## REMARKS

In the Office Action, the pending claims were rejected as follows. Claims 1, 2, 3, 4, 6, 7, 12, 13, 15 and 18 were rejected under 35 U.S.C. §102(b) as being anticipated by U.S. Patent 5,843,169 to Taheri; Claim 5 was rejected under 35 U.S.C. §103(a) as being unpatentable over Taheri in view of U.S. Patent 6,193,745 to Fogarty et al.; Claim 8 was rejected under 35 U.S.C. §103(a) as being unpatentable over Taheri in view of U.S. Patent 6,312,457 to DiMatteo et al.; Claim 9 was rejected under 35 U.S.C. §103(a) as being unpatentable over Taheri in view of U.S. Patent 5,360,443 to Barone et al.; Claims 10 and 11 were rejected under 35 U.S.C. §103(a) as being unpatentable over Taheri in view of Barone et al. further in view of U.S. Patent No. 6,702,844 to Lazarus; Claim 14 was rejected under 35 U.S.C. §103(a) as being unpatentable over Taheri in view of U.S. Patent 5,720,776 to Chuter et al.; and Claims 16, 17 and 19-22 were rejected under 35 U.S.C. §103(1) as being unpatentable over Taheri in view of U.S. Patent 6,911,035 to Blomme. The Office Action also objected to the drawings as failing to comply with 37 CFR 1.84(p)(5) for including reference numbers that are not mention

Enclosures: Corrected Drawing Sheet for Figs 20A-20C, with changes marked in red; and  
*Submission of Replacement Drawing Sheet*

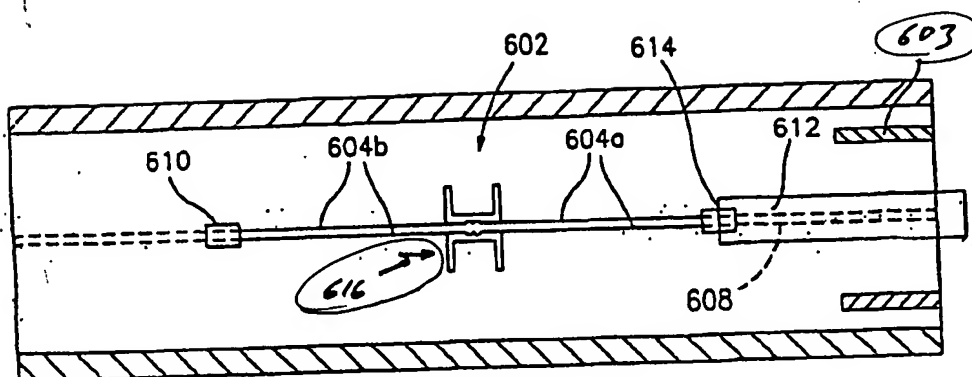
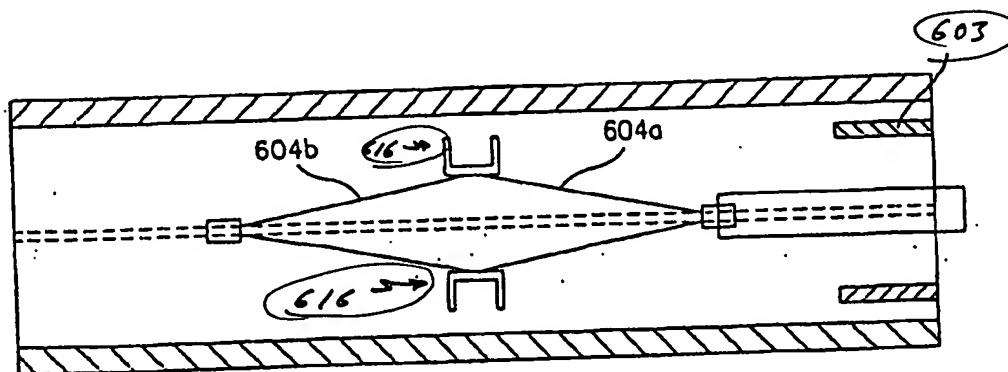
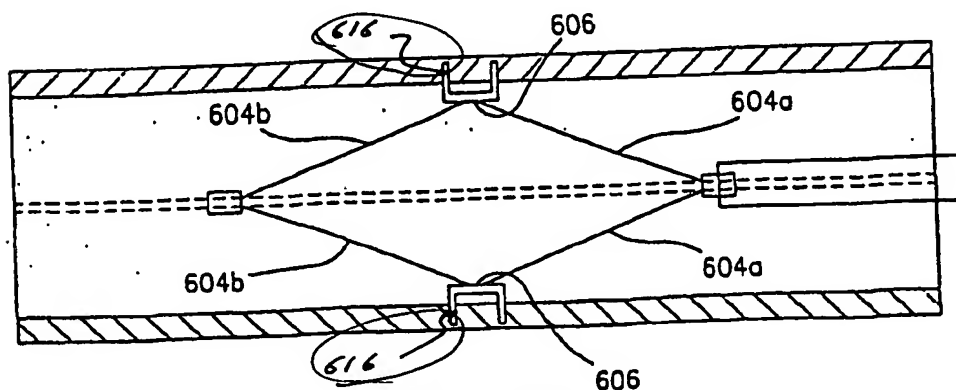
In regard to the objection to the drawings, at page 2, the Office Action indicated that reference numbers mentioned in the description are missing for item 616 in Figs 21A, 21B and 21C. In response, it is noted that paragraph 0051 of the specification has been amended to correct the reference from Figs. 21A, 21B and 21C to Figs, 20A, 20B and 20C. In addition, enclosed herewith for the Examiner's approval are corrected drawings for Figs. 20A, 20B and 20C that include numeral 616 requested in the Office Action as well numeral 603, in accordance with the description provided in the Specification. See ¶0051. Changes are circled in red ink for the Examiner's convenience. A *Submission of Replacement Drawing Sheet* is also enclosed, which is believed overcomes the objection.
